# Enterprise Recycling & Disposal Facility

Angelo's Aggregate Materials, Ltd.

Pending Modification Permit Nos. 0177892-005-SO/MM and  
0177982-006-SC/MM

## Response to Requests for Additional Information

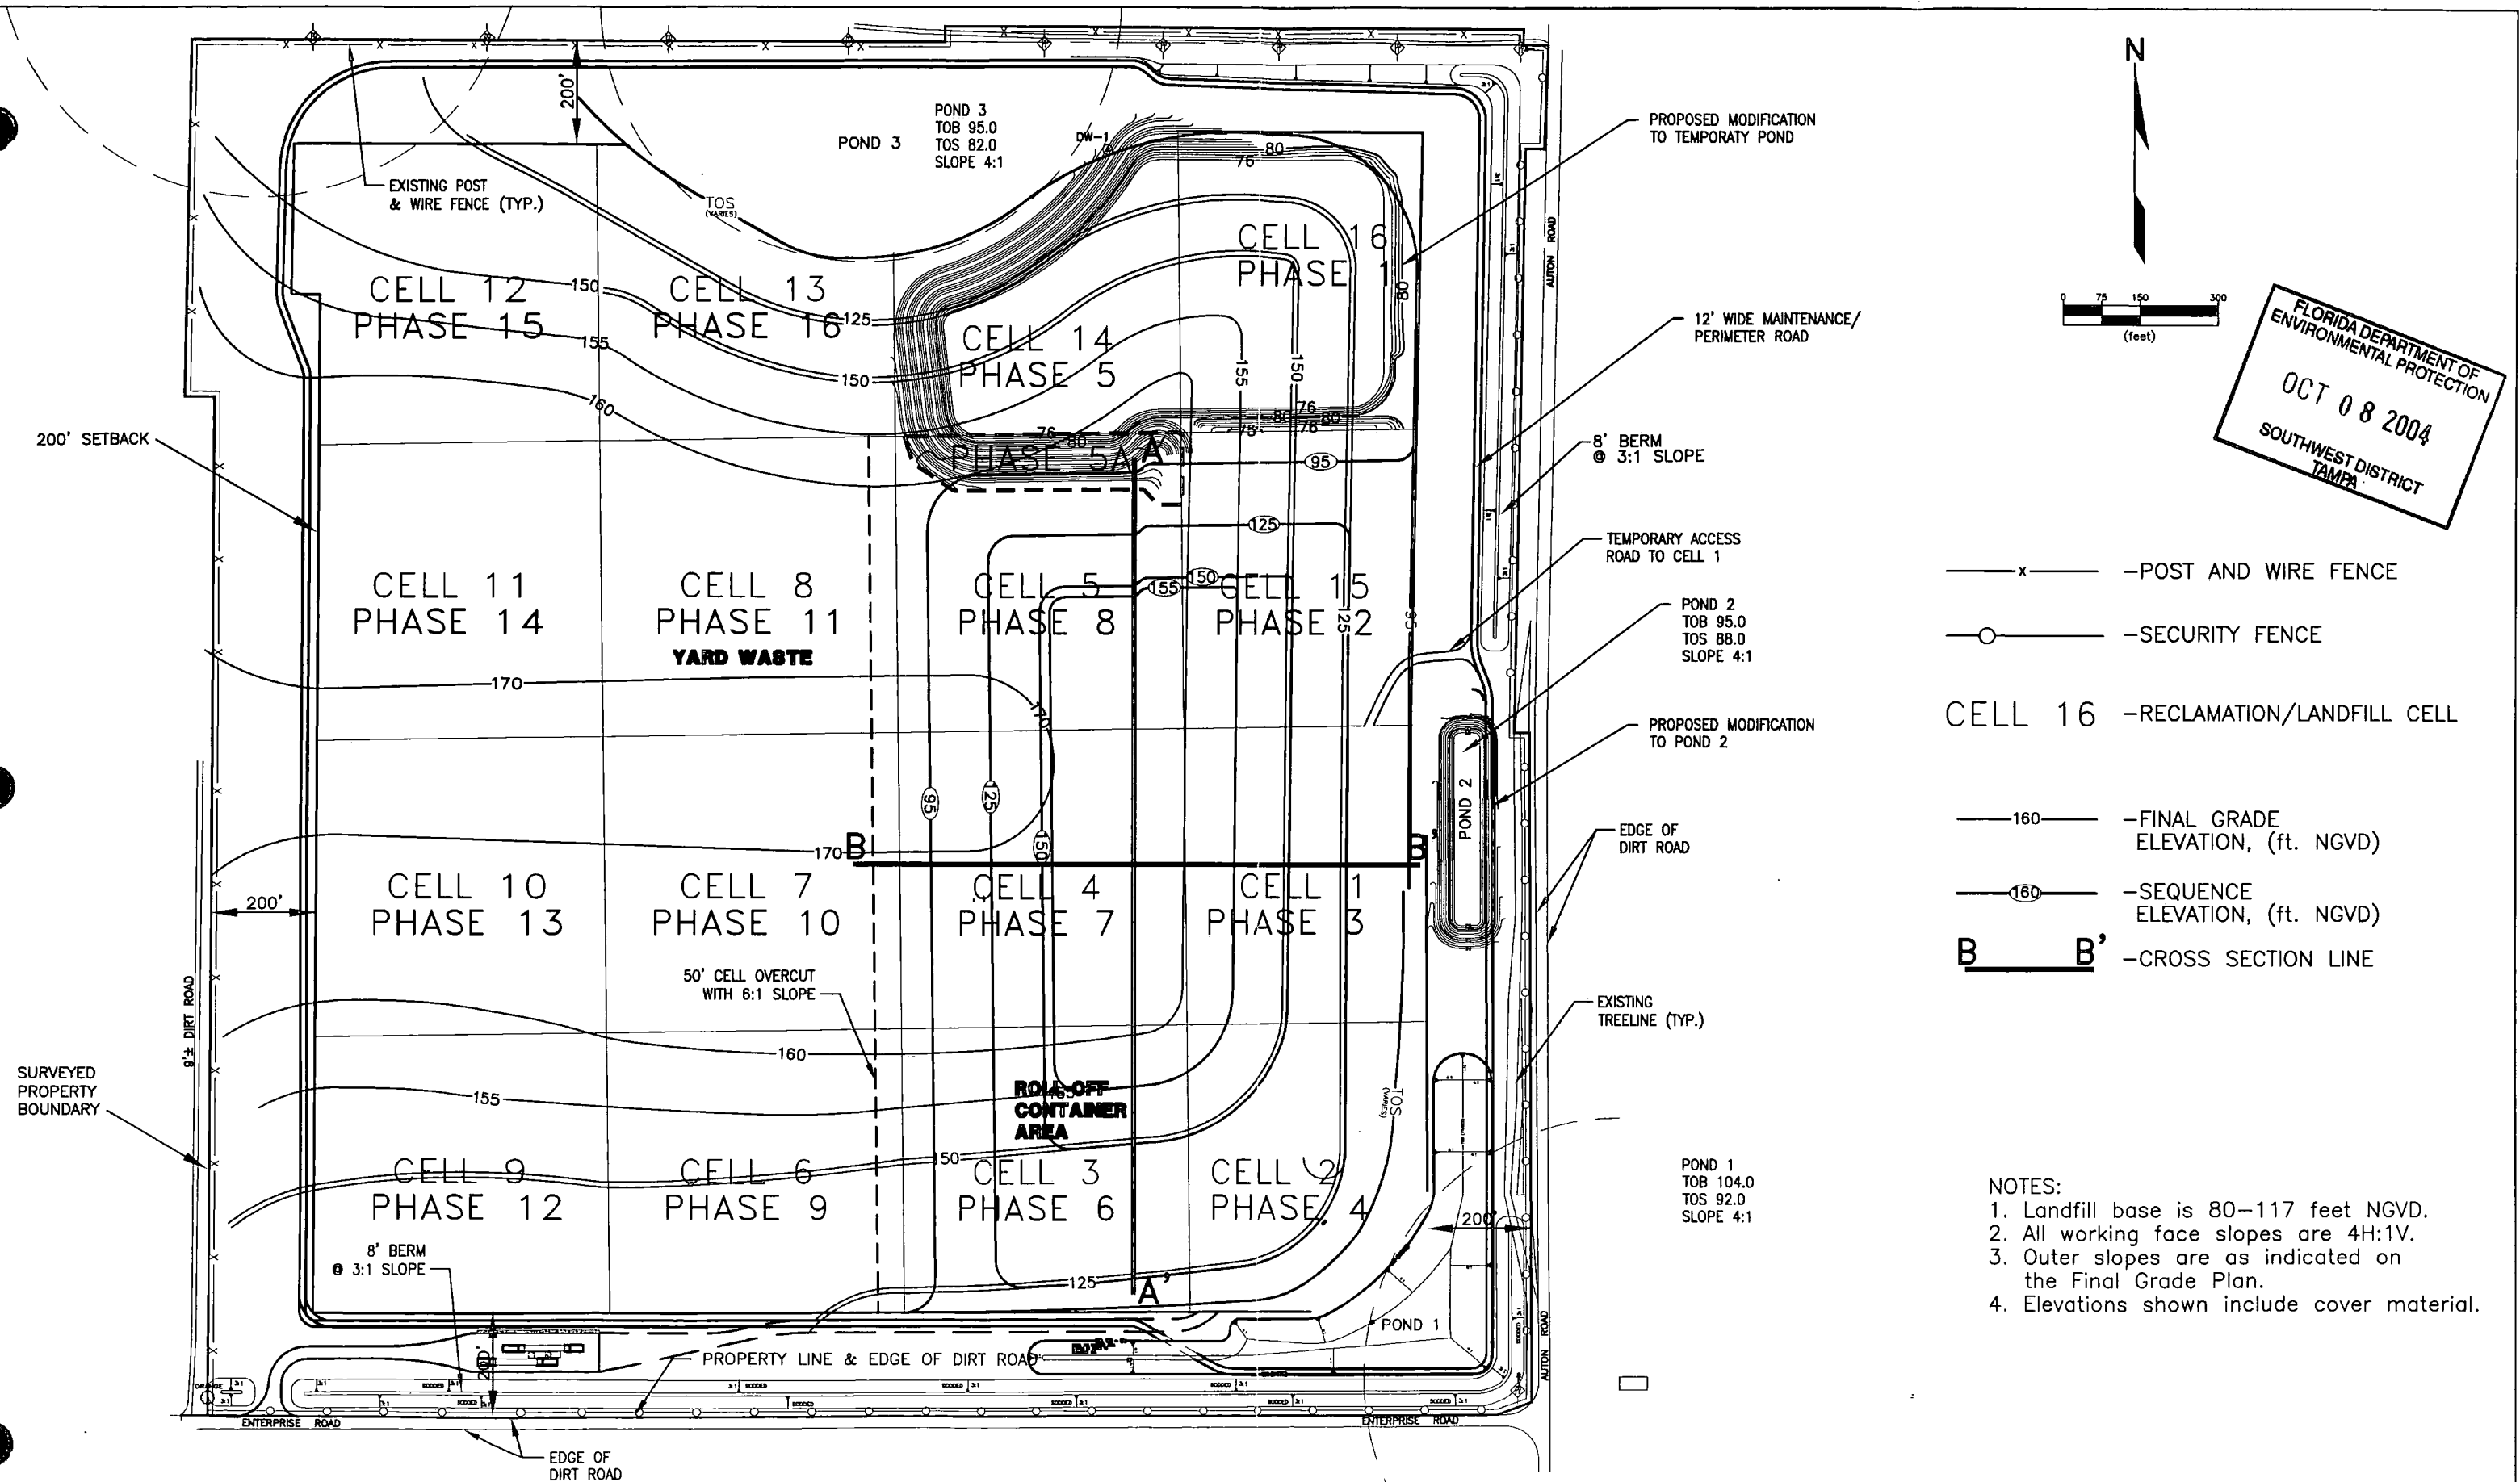
29. Figure 3-18 has not been revised to show the paved parking, gatehouse and septic tank as "existing".

29. Figure 3-18 indicates that paved parking, gatehouse and septic tank are proposed. Please verify whether these features are proposed or existing and revise Figure 3-18 accordingly.

**Response:** The appropriate existing facilities have been added to Figure 3-18.

**Response:** The paved parking, scale house, and septic tank are installed and Figure 3-18 has been revised accordingly.

WELL LOCATION MAP  
ENTERPRISE ROAD RECYCLING AND DISPOSAL FACILITY  
DADE CITY, FLORIDA

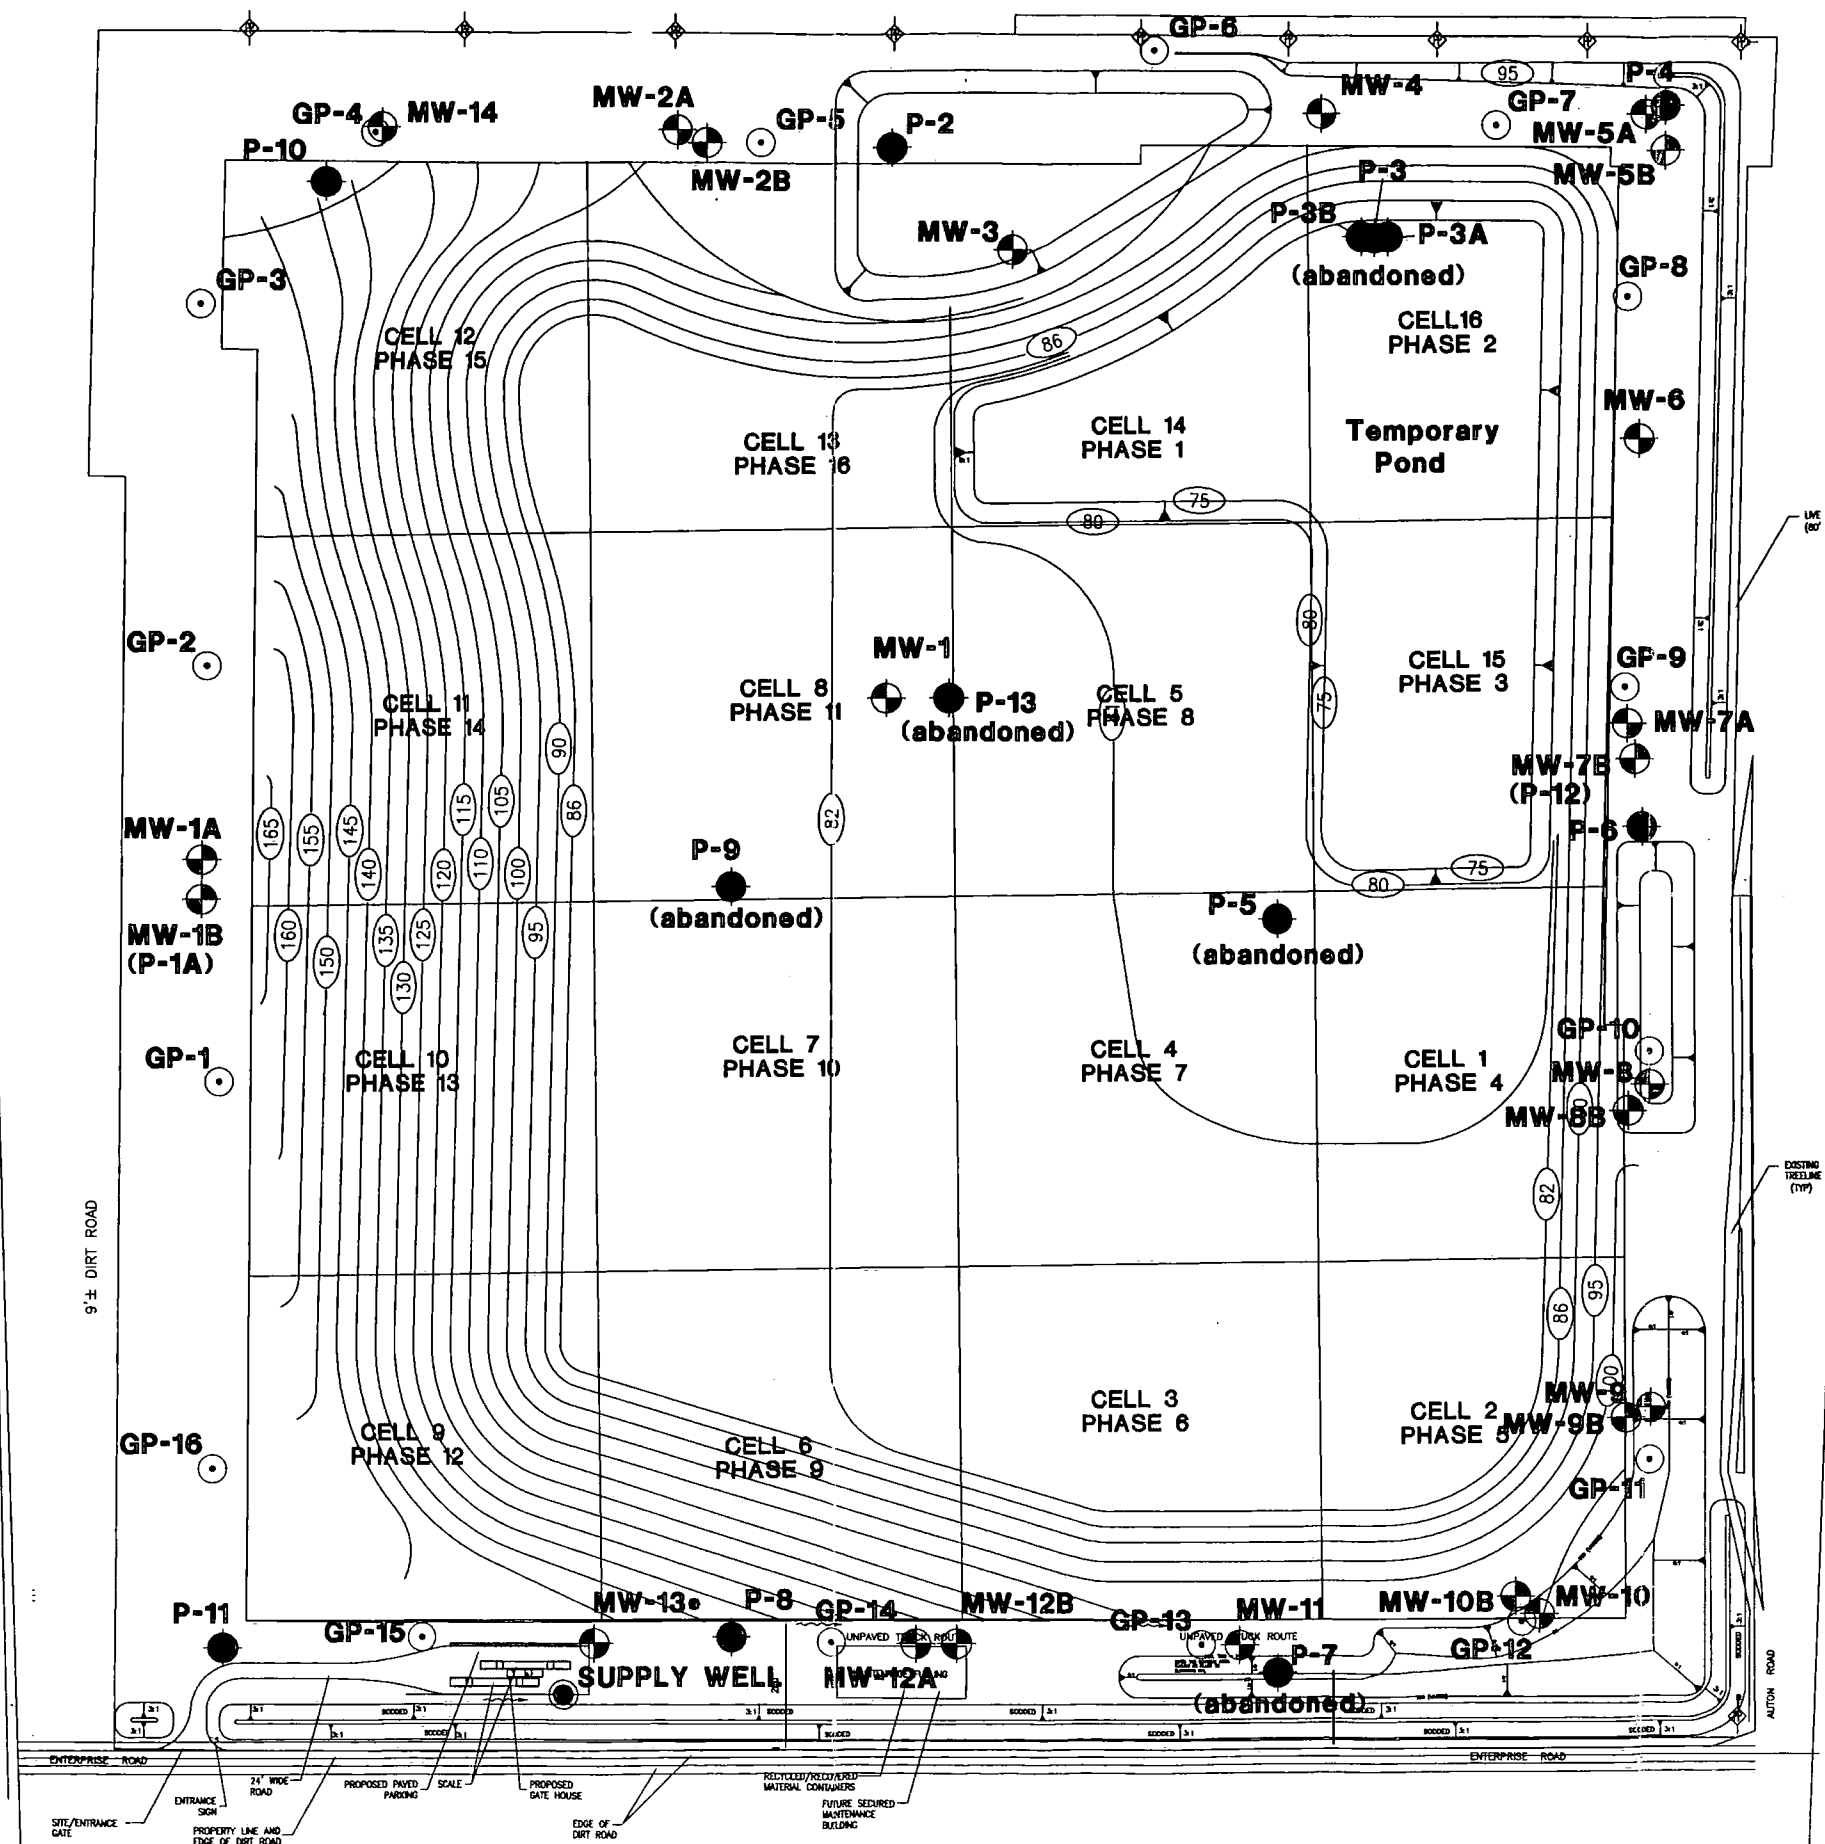
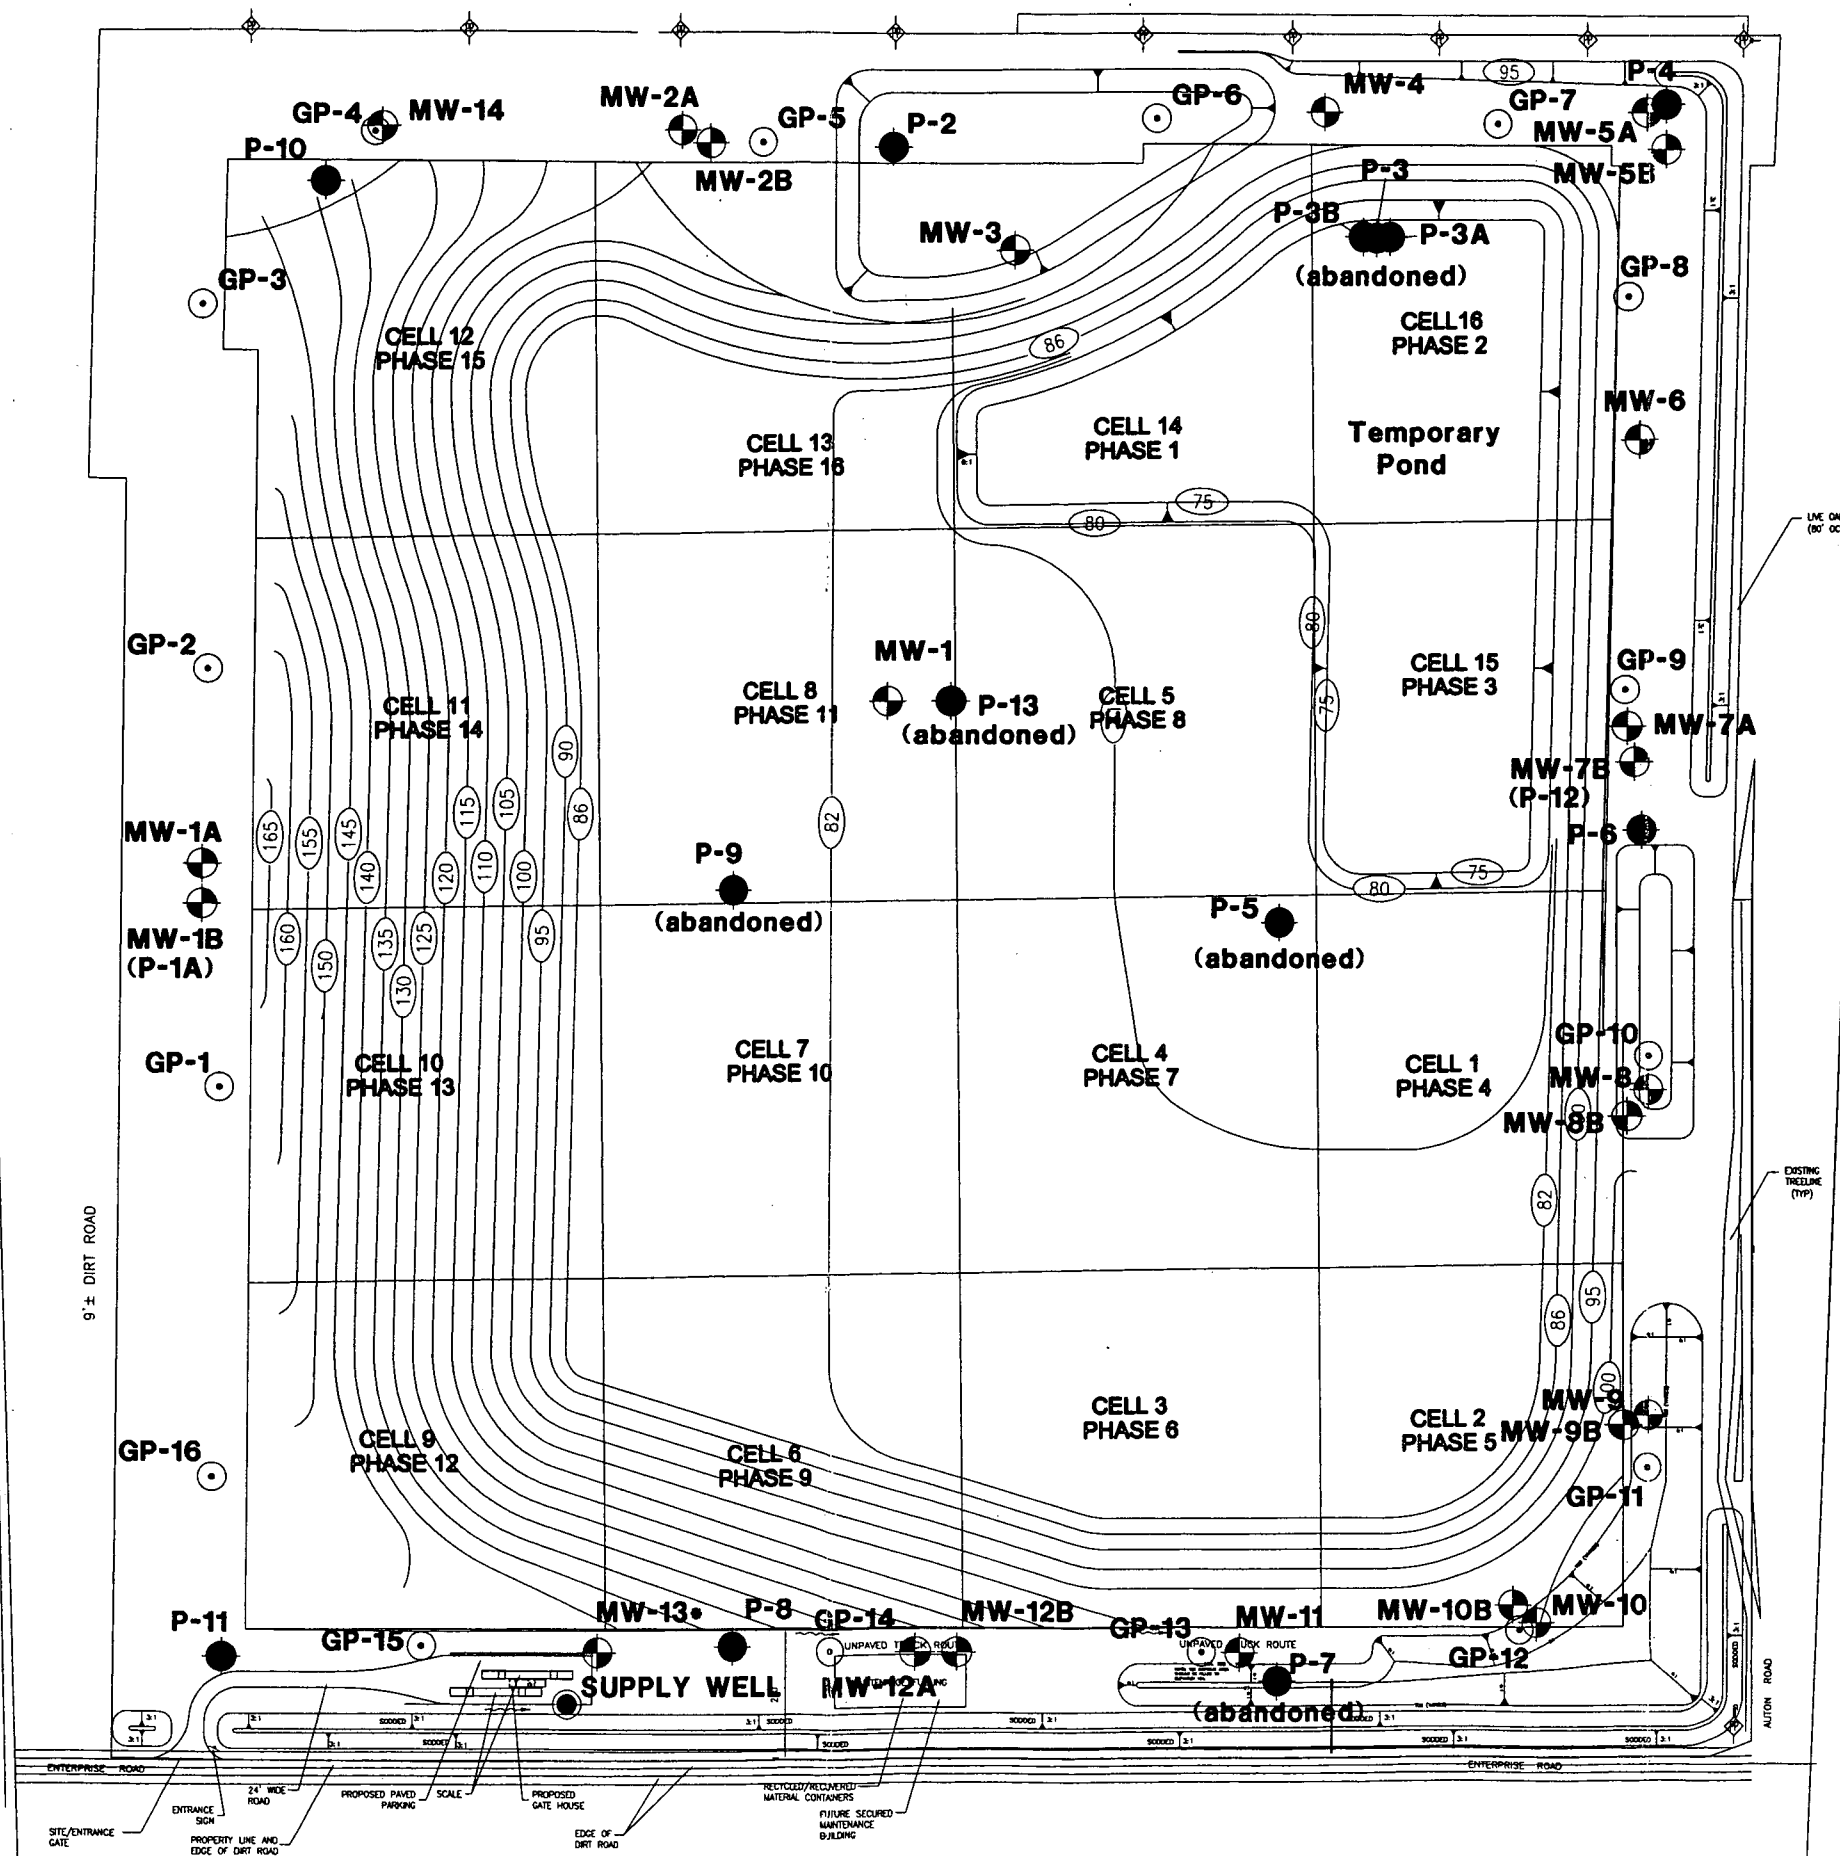
18. GP-6 is shown as located inside stormwater pond 3 in Figure 1A. Please address.

**Response:** Please see the attached Figure 1, Well Location Map. Locations of all approved gas probe locations are indicated by the designation GP-#. Probes GP-9, GP-10, GP-11, GP-12, GP-13, and GP-14 are installed and included in the quarterly gas monitoring activities. Probes

**Response:** Section 3.3 of the Engineering Report has been revised to include use of the referenced well. Figure 1 has been revised to include the location of the supply well.

**Response:** Supplemental monitor well locations are included in Figure 1, attached. Justification of construction details for the upper Floridan aquifer wells adjacent to the existing wells MW-8, MW-9, and MW-10 is included in the form of boring logs from the each of the adjacent wells, and a proposed monitor well construction diagram, Figure 2. The location and unique identification numbers of the supplemental wells are included on Figure 1.
